PRODUCT CHANGE NOTIFICATION (PCN)

A-MCSP-80005/R MODULAR CABLE

CHANGE NOTIFICATION: PCN 20220425_A-MCSP-80005/R

DESCRIPTION OF CHANGES: CHANGE OF DATA SHEET
CHANGE OF DATA SHEET
New Draw.-No. ASS_7425_CArev07

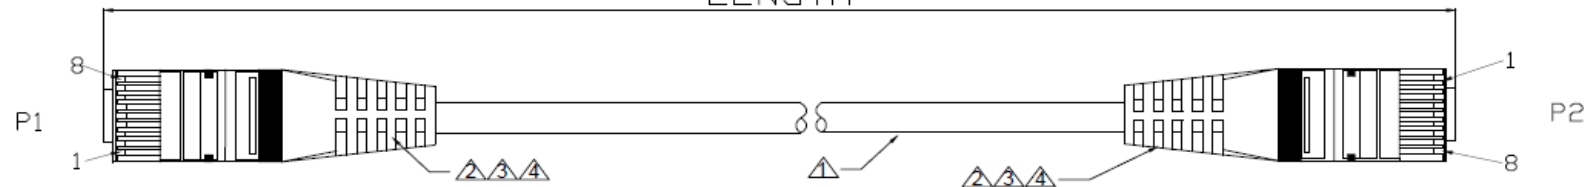
A-MCSP-80005/R	OLD VERSION	A-MCSP-80005/R	NEW VERSION																																																	
<p>Appearance</p>		<p>Appearance</p>																																																		
<p>BOM</p> <table border="1"> <thead> <tr> <th>NO</th> <th>PART NO</th> <th>DESCRIPTION</th> <th>QTY</th> <th>UNIT</th> </tr> </thead> <tbody> <tr> <td>3</td> <td>mold</td> <td>PVC,50P</td> <td>9.0</td> <td>G</td> </tr> <tr> <td>2</td> <td>plug</td> <td>8P8C plating gold 3U* with metal shield</td> <td>2</td> <td>PCS</td> </tr> <tr> <td>⑤ 1</td> <td>cable</td> <td>FTP (26AWG*1P)*4+D+A+PVC, OD:5.2±0.2mm CAT5E</td> <td>2.0</td> <td>M</td> </tr> </tbody> </table>		NO	PART NO	DESCRIPTION	QTY	UNIT	3	mold	PVC,50P	9.0	G	2	plug	8P8C plating gold 3U* with metal shield	2	PCS	⑤ 1	cable	FTP (26AWG*1P)*4+D+A+PVC, OD:5.2±0.2mm CAT5E	2.0	M	<p>BOM</p> <table border="1"> <thead> <tr> <th>NO</th> <th>PART NO</th> <th>DESCRIPTION</th> <th>QTY</th> <th>UNIT</th> </tr> </thead> <tbody> <tr> <td>⑦</td> <td>⚠</td> <td>AL-Foil</td> <td>Double-sided conductive aluminum foil</td> <td>2</td> <td>PCS</td> </tr> <tr> <td>⑦</td> <td>⚠</td> <td>mold</td> <td>PVC,65P</td> <td>AR</td> <td>G</td> </tr> <tr> <td></td> <td>⚠</td> <td>plug</td> <td>8P8C plating gold 3U* with metal shield</td> <td>2</td> <td>PCS</td> </tr> <tr> <td>⑦⑤</td> <td>⚠</td> <td>cable</td> <td>CAT5E F/UTP (26AWG*1P)*4+D+A+PVC, OD:5.2±0.2mm</td> <td>AR</td> <td>M</td> </tr> </tbody> </table>		NO	PART NO	DESCRIPTION	QTY	UNIT	⑦	⚠	AL-Foil	Double-sided conductive aluminum foil	2	PCS	⑦	⚠	mold	PVC,65P	AR	G		⚠	plug	8P8C plating gold 3U* with metal shield	2	PCS	⑦⑤	⚠	cable	CAT5E F/UTP (26AWG*1P)*4+D+A+PVC, OD:5.2±0.2mm	AR	M

NO	PART NO	DESCRIPTION	QTY	UNIT																																																
3	mold	PVC,50P	9.0	G																																																
2	plug	8P8C plating gold 3U* with metal shield	2	PCS																																																
⑤ 1	cable	FTP (26AWG*1P)*4+D+A+PVC, OD:5.2±0.2mm CAT5E	2.0	M																																																
NO	PART NO	DESCRIPTION	QTY	UNIT																																																
⑦	⚠	AL-Foil	Double-sided conductive aluminum foil	2	PCS																																															
⑦	⚠	mold	PVC,65P	AR	G																																															
	⚠	plug	8P8C plating gold 3U* with metal shield	2	PCS																																															
⑦⑤	⚠	cable	CAT5E F/UTP (26AWG*1P)*4+D+A+PVC, OD:5.2±0.2mm	AR	M																																															
<p>FOR DETAIL, PLEASE TAKE ATTACHED NEW DRAWING: FOR REFERENCE</p>

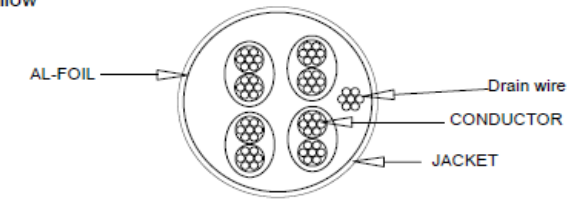
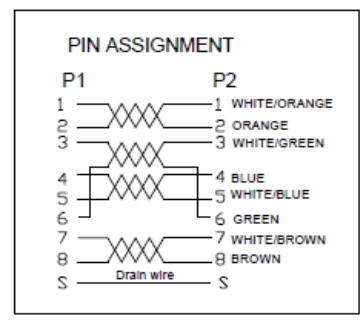
NO	PART NO	DESCRIPTION	QTY	UNIT
⑦	④	AL-Foil Double-sided conductive aluminum foil	2	PCS
⑦	④	mold PVC,65P	AR	G
⑦	④	plug 8P8C plating gold 3U* with metal shield	2	PCS
⑦⑤	④	cable CAT5E F/UTP (26AWG*1P)*4+D+A+PVC, OD:5.2±0.2mm	AR	M

Scale	FREE	⑦	Change the plant	12.04.2022	Luca	Date	Name	Customer-No.
TOLERANCE		⑥	Clarify the tolerance	23.08.2018	Segal	26.06.2015	Joanna	ASSMANN WSW-No. A-MCSP-80XXX/X
X.	±X	⑤	Add "CAT5E"	20.10.2017	Stephon	12.04.2022	Luca	
X.X	±X	④	Add length for 20M and 30M	20.09.2017	Fred			
X.XX	±X	③	remove mark on the mould	29.06.2016	Joanna			
DIM	TOL	②	Add length for 300mm	18.05.2015	Joanna			Drawing-No.
ANGLE	±X°							ASS 7425 CA
Angle	TOL	Id.	Modification	Date	Name			rev07
								Sheet
